## **Chester Bowl Chalet**

Accessibility Review

Chester Bowl Chalet  
 Upper Level  
 City of Duluth, MN

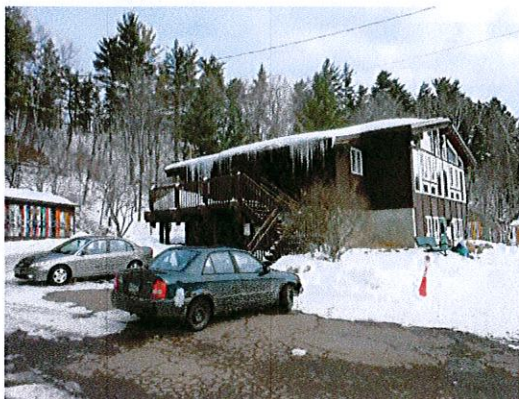
**Photo 1:** There is not currently an accessible route to the upper level.

**Photo 2:** Patch the rise at the lower level entry.

**Photo 3:** Eliminate the step at the entry to the toilet rooms and replace the thumb-latch style door hardware.

**Photo 4:** The toilet rooms provide an ambulatory accessible stall, but not a 5' accessible stall.

**Photo 5:** View of vestibule at toilet room entry. The vestibule is too small to provide turning space or maneuvering clearance at any of the doors.

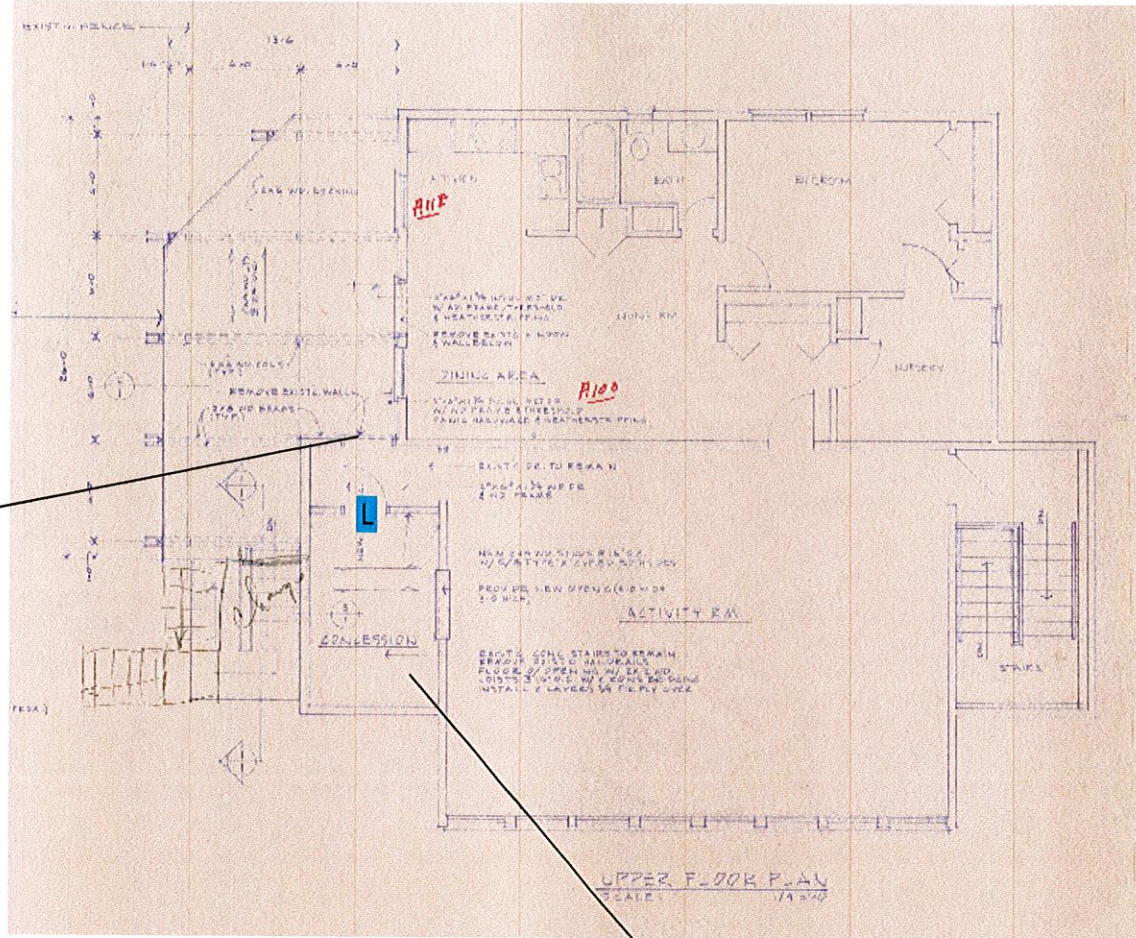
Add raised and braille signs

Create an accessible route

Lower the concession counter to 36" max.  
Replace the faucet hardware

L Install door lever hardware
